PROJECT:  
**THE RIDGE AT LORSON RANCH**  
 FONTAINE BLVD. - WALLEYE DR  
 COLORADO SPRINGS, COLORADO

**THE RIDGE AT LORSON RANCH  
OVERLOT EARLY GRADING AND  
EROSION CONTROL PLAN**

Unresolved comment from Review #1:  
 Sediment traps are not sufficient for this application. According to MHFD Detail SC-8, they are for disturbed tributary areas <1ac. For >1ac, a sediment basin is more appropriate or add more more traps upstream. Calculate and show approx tributary area. The one to the right has >5ac trib to it.  
 And sediment traps should not block site access roads.

WQ POND F  
1"=20'

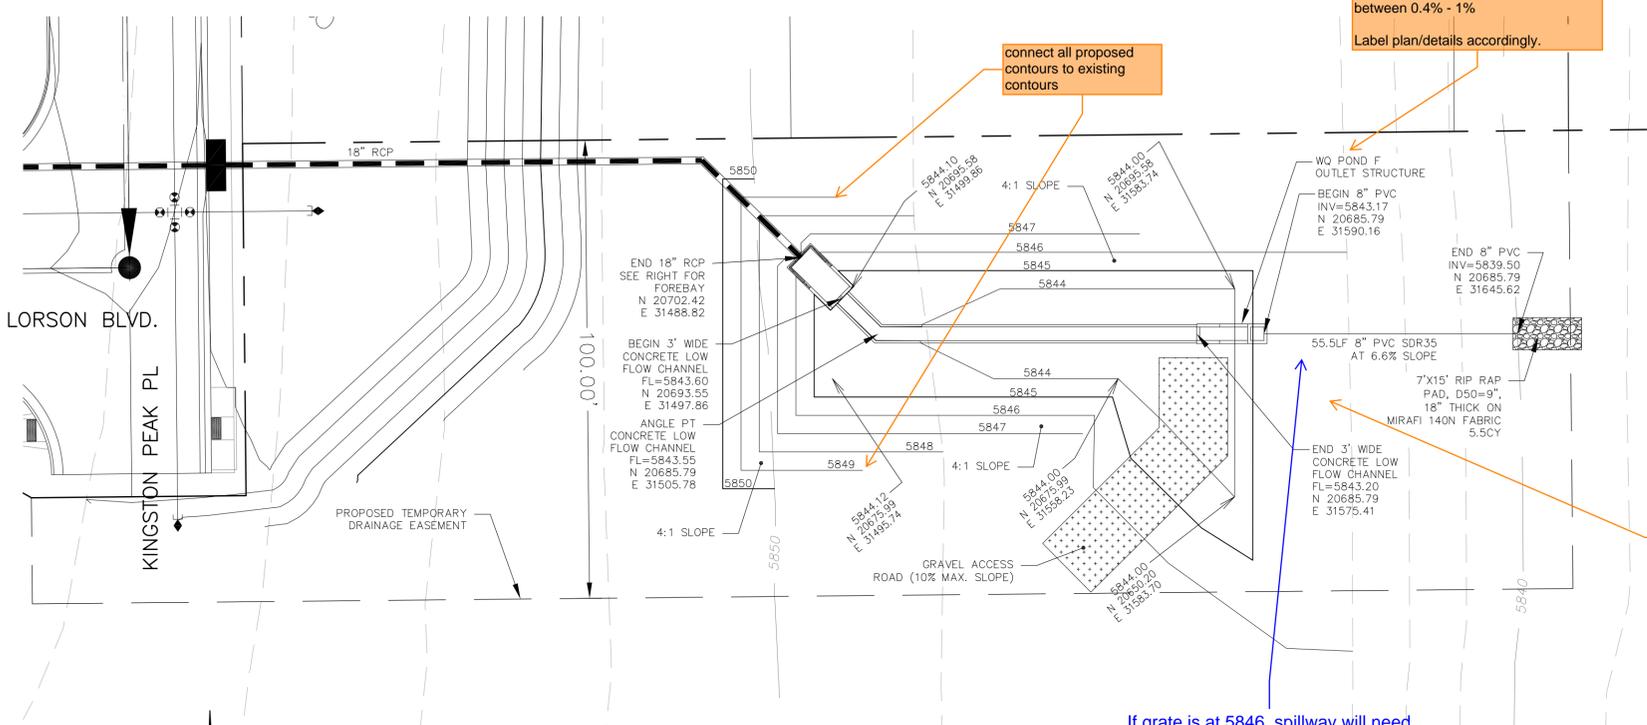
Provide detailed plan and section view of outlet structure too, per calcs shown on pg 193 of PDR.  
Per MHFD Detail T-5:  
- pond bottom should have a minimum slope of 3%.  
- trickle channel should have a slope between 0.4% - 1%  
Label plan/details accordingly.

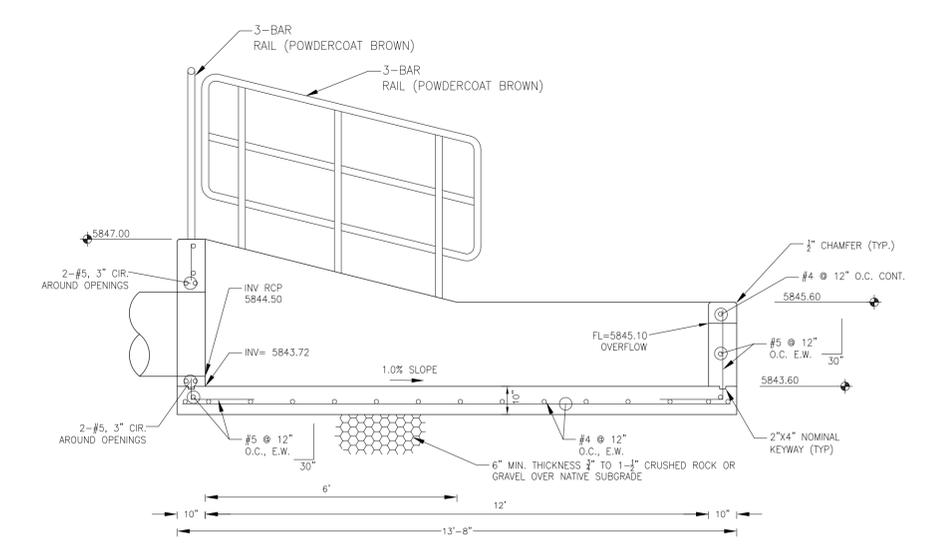
If grate is at 5846, spillway will need to be higher. Overtopping will happen relatively often, so the downstream conveyance needs to be designed for undetained 100-year developed flow.
